MARINE ENVIRONMENT PROTECTION
COMMITTEE
59th session
Agenda item 4

MEPC 59/4/29
8 May 2009
Original: ENGLISH

Consideration of the Energy Efficiency Design Index for New Ships

Refinements to the “draft guidelines on the method of calculation of the energy efficiency design index for new ships” for non-conventional passenger ships

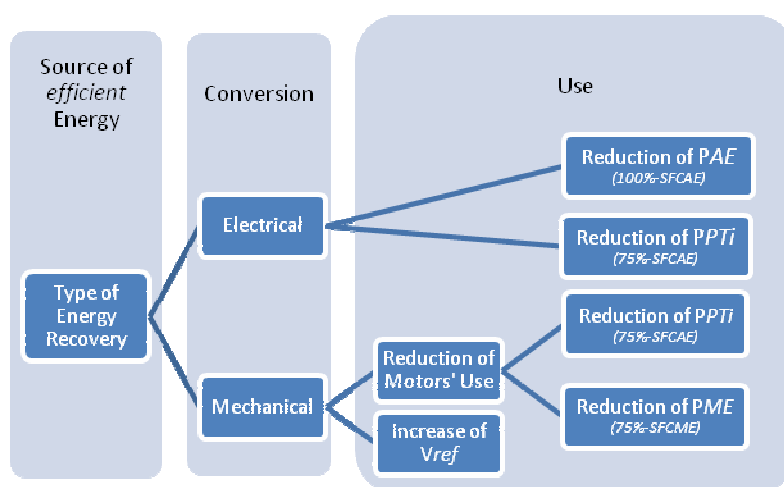
17 The following diagram demonstrates the efficient use of energy concept. It shows that any type of energy recovery can be used in several different ways that apparently has not been considered by the current EEDI formula.

17.1 With reference to the above diagram, the following “Type of Efficient use of Energy” have been identified: 1) Main Engine Waste heat recovery, 2) Auxiliary engines Waste heat recovery, 3) Wind Power, 4) Solar Power, 5) CO₂ capturing, 6) air lubricating and 7) new future ship and propulsion types.

17.2 From the above diagram, it is easier to understand that power resulting from a “type of efficient use of energy” can lead to a different EEDI upon its conversion and use. For example, the waste heat recovery from the auxiliary engines can be converted into electrical power via a steam turbine generator. Such electrical power can be utilized to supply a part of the auxiliary power (P_{AE}). Alternatively, it could be utilized to supply a quota of the shaft motors’ power ($P_{PTI(i)}$). The current formula infers that the electrical power from energy recovery (P_{Aeff}) can reduce the auxiliary power (P_{AE}) only and not the power $P_{PTI(i)}$. This is not always possible as shown in the document GHG-WG 2/2/17; potentially the power for energy recovery could be greater than the total power P_{AE} and consequently the excess power must contribute to the power $P_{PTI(i)}$. As the current formula state that P_{AE} ’s CO₂ production has to be considered at 100%, while the $P_{PTI(i)}$ ’s CO₂ production has to be considered at 75%, this example demonstrates that the EEDI can substantially vary upon the use of the energy recovery and the calculation method of the EEDI.

Marine plant diagram for non-conventional passenger ships

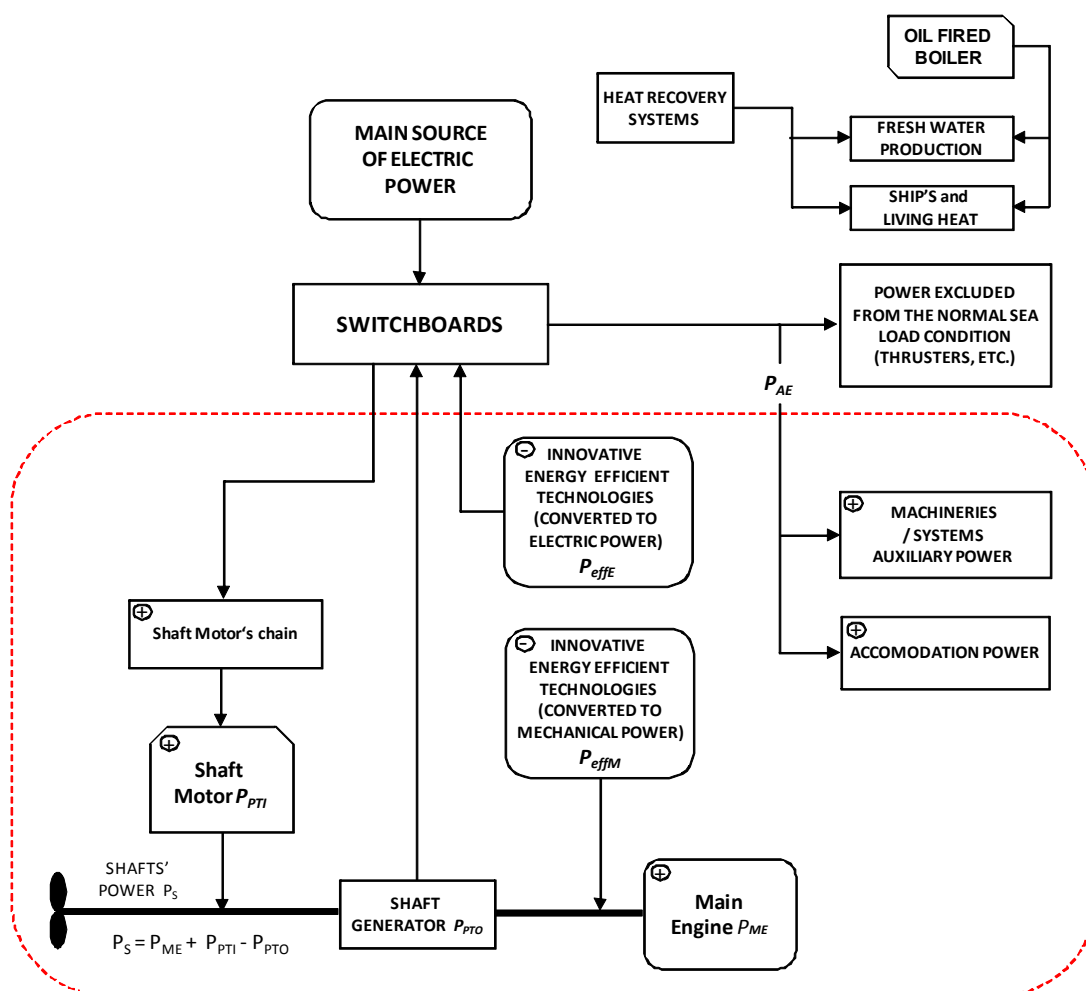
21 A new diagram is introduced where the circles indicate the CO₂ contribution (+/-) to the
EEDI formula.
